Item No. 3 Zoning Agreement Amendment - 5 Scurfield Boulevard (River Heights-Fort Garry Ward) File ZAA 16/2008

RE: **Zoning Agreement Amendment - 5 Scurfield Boulevard**
File ZAA 16/2008 [c/r DAV 131179/2008D]

DATE:	September 11, 2008
FILE:	**ZAA 16/08**
RELATED FILES:	DAV 08-131179/D, DASZ 44/79
SUBJECT:	To amend the Zoning Agreement affecting the land shown outlined below by deleting the width requirement stated in Clause 5 and replacing it with "1.2 metres (four feet)".
LOCATION:	**5 Scurfield Boulevard, at Waverley Street**
LEGAL DESCRIPTION:	LOT 6 BLOCK 7 PLAN 15345 16/23 ST V OTM
APPLICANT:	Frieder Aldinger, MMM Group Limited 93 LOMBARD AVE SUITE 111 WINNIPEG MB R3B 3B1
OWNER:	2253062 MANITOBA LIMITED C/O MMI COMMERCIAL REAL ESTATE LTD ATTN: LINDSEY SAUNDERS 430 DOVERCOURT DR UNIT A WINNIPEG MB, R3Y 1N4
RECOMMENDATION:	***Not* Proceed With.**

Exhibit "8" referred to in File ZAA 16/2008 [c/r DAV 131179/2008D]

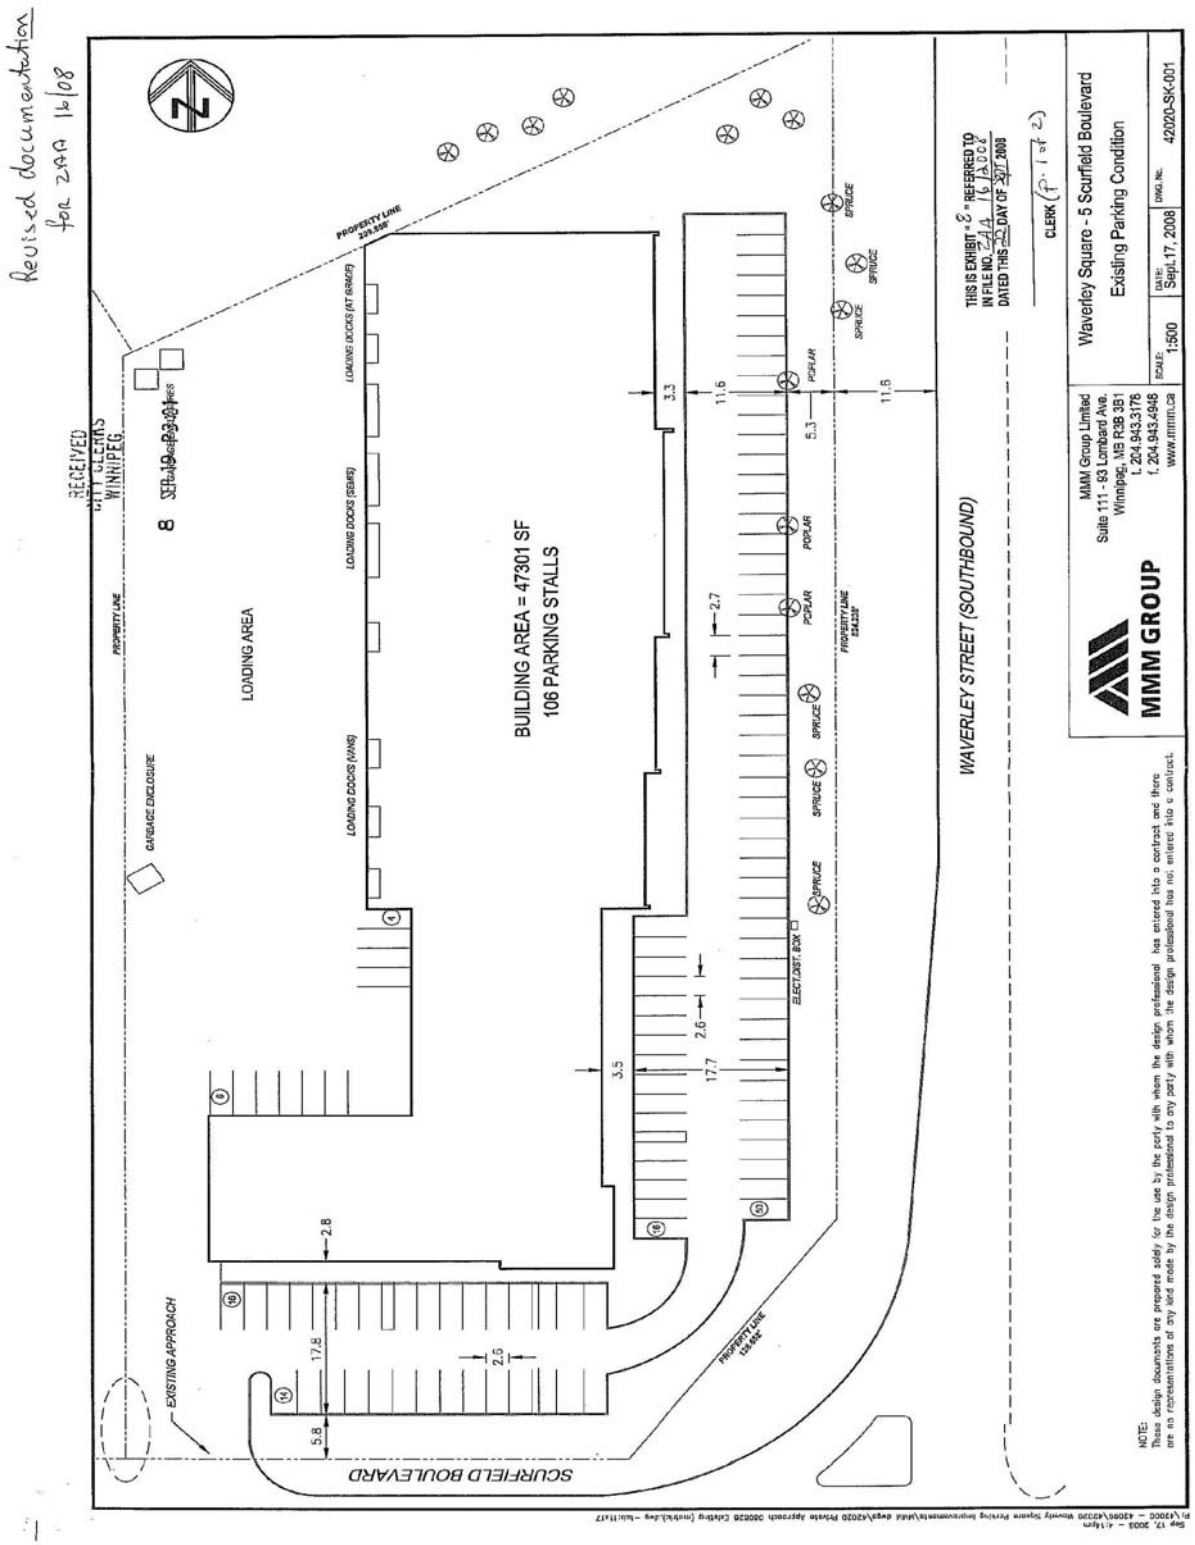
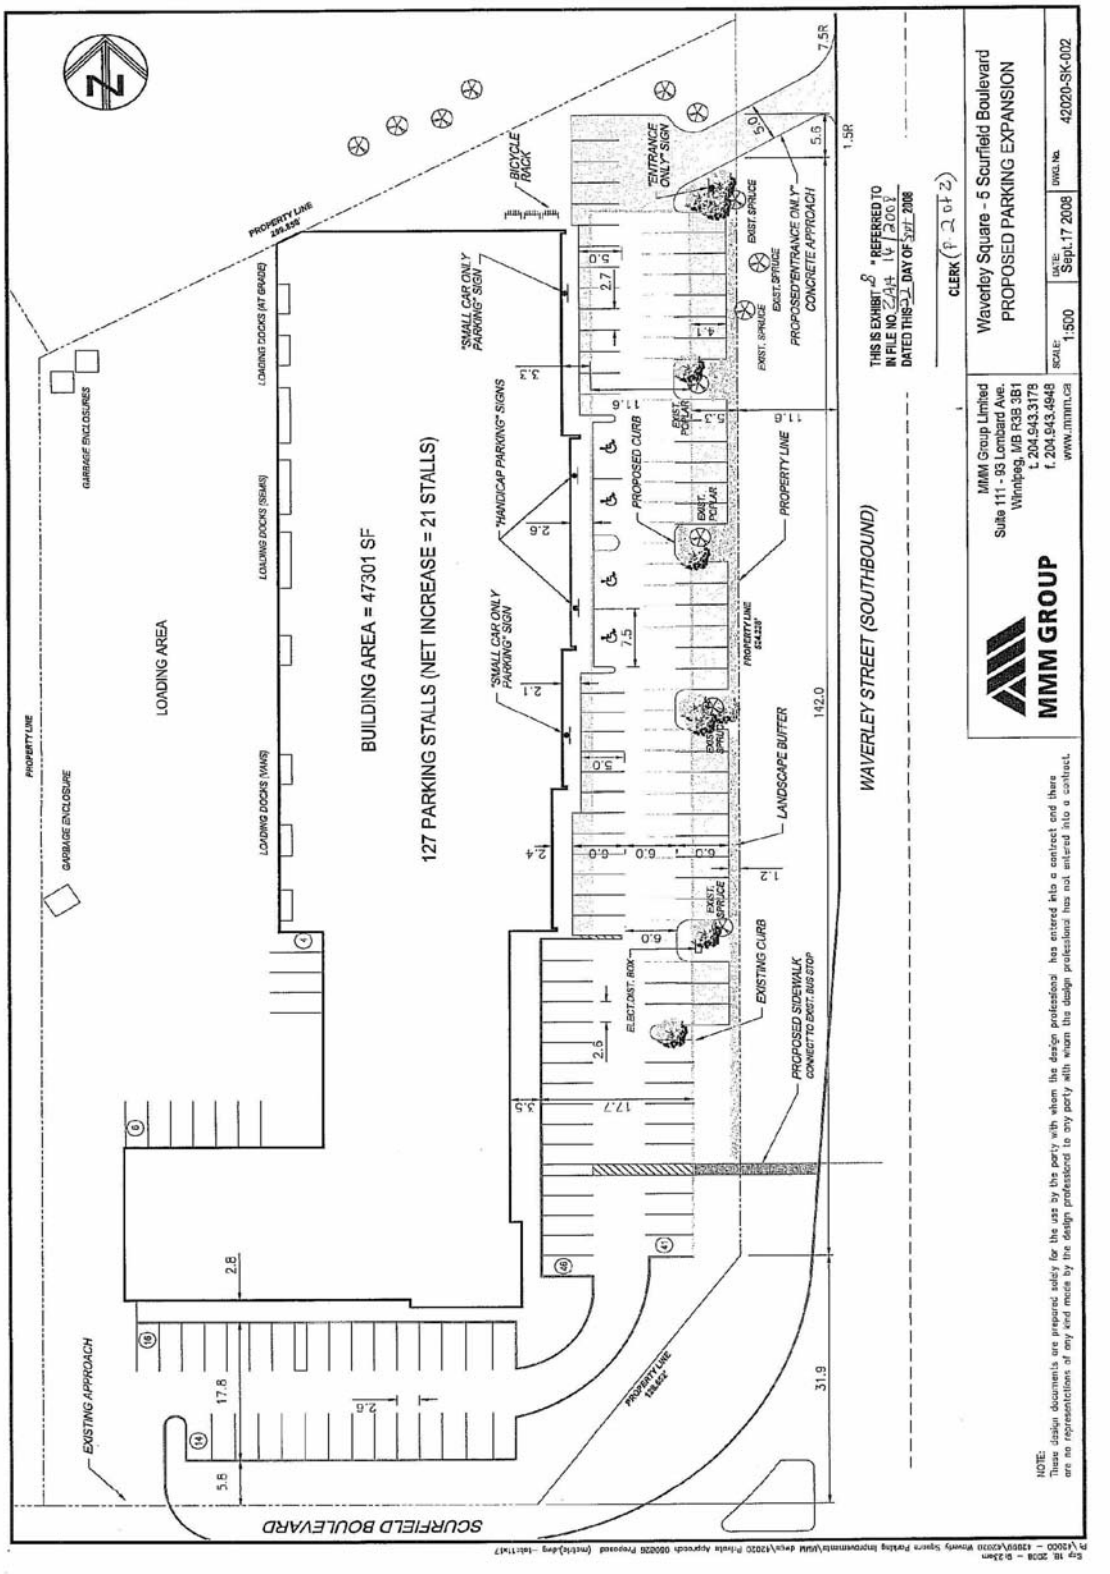
The proposed location for the bicycle parking, illustrated in Sheet 2 of 2 of a site plan submitted in connection with the aforementioned File DAV 08-131179/D, is not visible from any main entrance to the units at 5 Scurfield Boulevard or to windows in the building on the subject land. In order to provide a sense of security, personal safety and convenience, the bicycle parking should be clearly visible to people in the building on the subject land and the main entrances should be clearly visible to people at the bicycle parking area(s).

The proposed four foot deep yard adjacent to Waverley Street is not compatible with land in the immediate vicinity of the subject land and the larger context of Waverley Street, between McGillivray and Bishop-Grandin Boulevards, because:

- lots immediately north, south across Scurfield Boulevard or east across Waverley Street have yards adjacent to Waverley with depths ranging from 18 to 27 feet, which is significantly more than the proposed yard depth; and
- almost all yards adjacent to Waverley Street, between McGillivray and Bishop-Grandin Boulevards, are at least 15 feet deep, which is also significantly more than the proposed yard depth.

While it is recognized that the preservation of several mature trees would mitigate, to some degree, the proposed east yard depth of only four feet it is noted that 31 parking spaces would be adjacent to the east yard, showing that most of the east yard would be four feet deep.

2. That bicycle parking be provide in accordance with Section 169 of The Winnipeg Zoning By-law No. 200/2006 and located such that it is clearly visible to people in the building on the subject land and the main entrances to the east side of the building are clearly visible to people at the bicycle parking area(s).

3. That a pedestrian connection to/from the building on the subject land and a Winnipeg Transit but stop be provided in substantial conformity with site plan filed as Exhibit 17 for File ZAA 16/2008.
